AP1000 CORE REFERENCE REPORT DCD (Rev. 19) Change Road Map

General Non-LOCA Change Summary

Figure 15.0.3-2

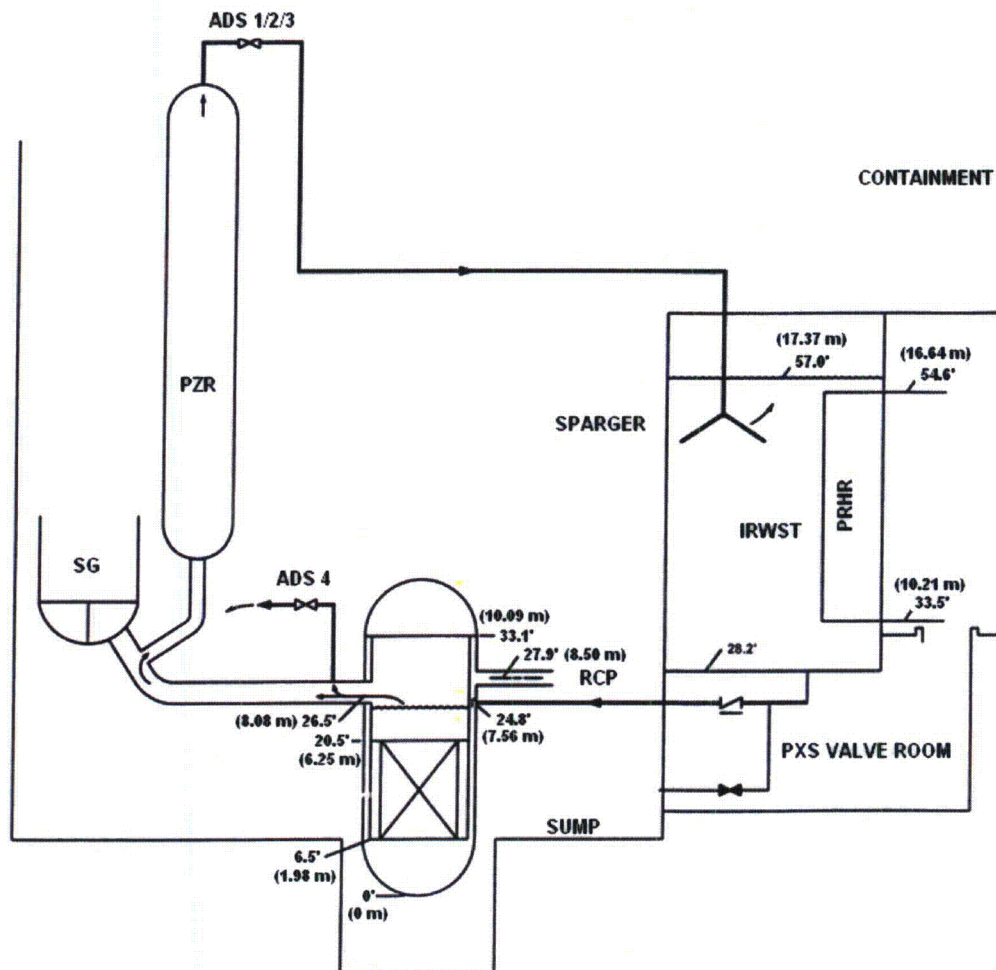
Comment [B54]: 15.0-54

Figure 15.0.5-1

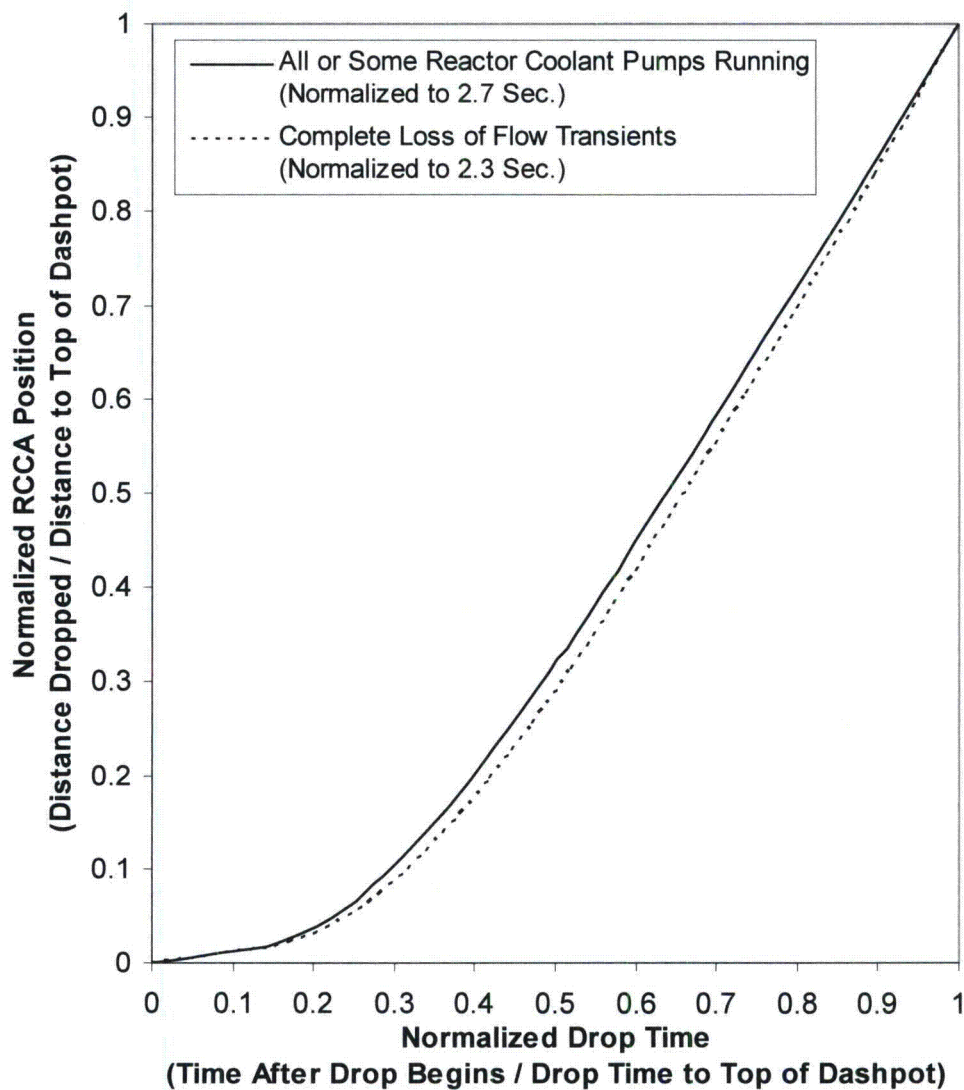
Comment [B55]: 15.0-55

Figure 15.0.5-3

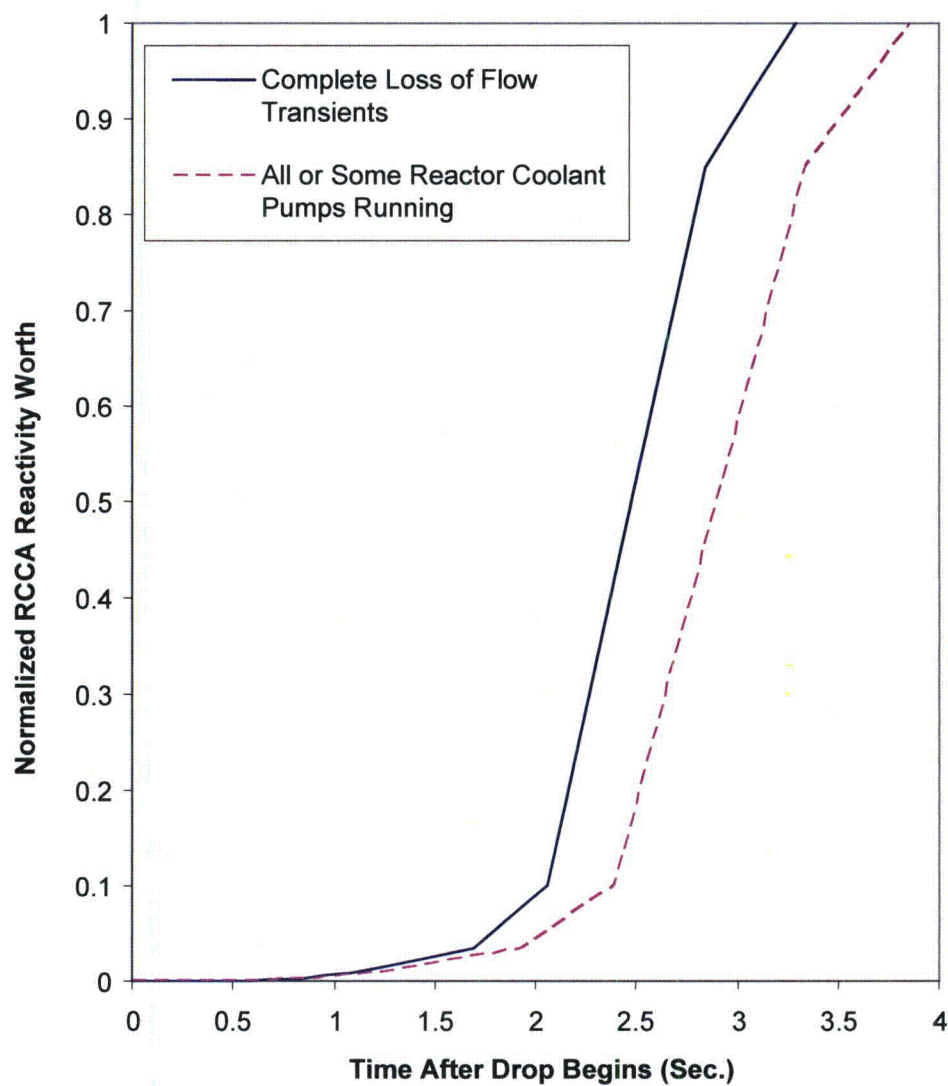
[15.0-56]	Figure 15.0.5-3	This figure reflects the revised rod insertion curve, updated for the new rod drop times, modeled in the Chapter 15 analyses for the AFC design.
[15.0-57]	Table 15.0-2 (Sheet 5 of 5)	This table has been updated consistent with the response provided to CRR-008.

Comment [B56]: 15.0-56
